Access Compliance Report

Public Rights-of-Way

(Curb Ramps)

Intersection ID: 8766	Main Street: ESTELLE_RD	Cross Street: MARIBEL_AV	Location:	S
ADA ID: DFE51DA6BBFE	Ramp Type: Perp	Initial Pass/Fail: Fail	Overall Compliance: No	Severity Score: 22.5

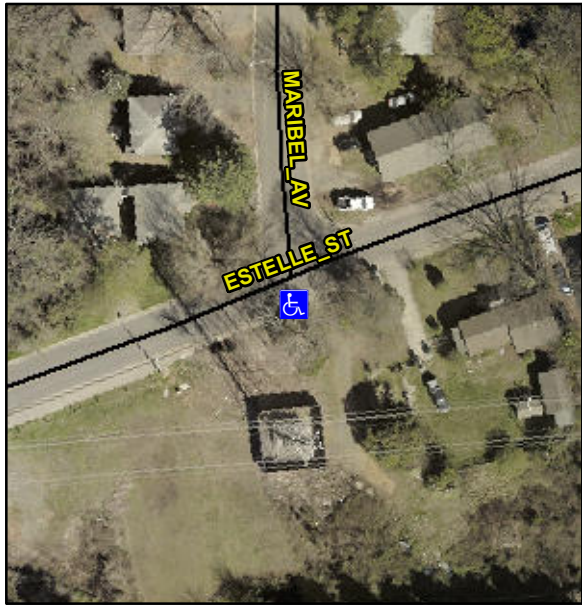
Codes/Mitigation Info/Possible Solution			Field Measurements/Component Compliance					
	Possible Solutions:		Compliance	Description	Data	Compliance	Description	Data
	Remove & Replace Entire Ramp.		N/A	Ramp Length (in)	25.5	No	Ramp Slope (%)	8.5
			No	Ramp Width (in)	46.5	No	Ramp XSlope (%)	4.8
			N/A	Flare Type LT	N/A	N/A	Flare Type RT	N/A
			N/A	Flare Slope LT (%)	N/A	N/A	Flare Slope RT (%)	N/A
			N/A	Flare Traversable LT?	N/A	N/A	Flare Traversable RT?	N/A
			N/A	Landing Length (in)	N/A	N/A	DWS Provided?	N/A
			N/A	Landing Width (in)	N/A	N/A	DWS Contrast?	N/A
			N/A	Landing Slope (%)	N/A	N/A	DWS Length (in)	N/A
			N/A	Landing X Slope (%)	N/A	N/A	DWS Full Width?	N/A
Surveyor Notes:			N/A	Landing Curb? (Y/N)	N/A	N/A	DWS Offset (in)	N/A
N/A			N/A	Shared Landing?	N/A			
PROW/ADA:			N/A	Gutter Ponding?	N/A	N/A	Gutter Slope (%)	N/A
R304.5.1, R304.2.2, R304.5.3			N/A	Gutter Lip Ht (in)	N/A	N/A	Gutter X Slope (%)	N/A
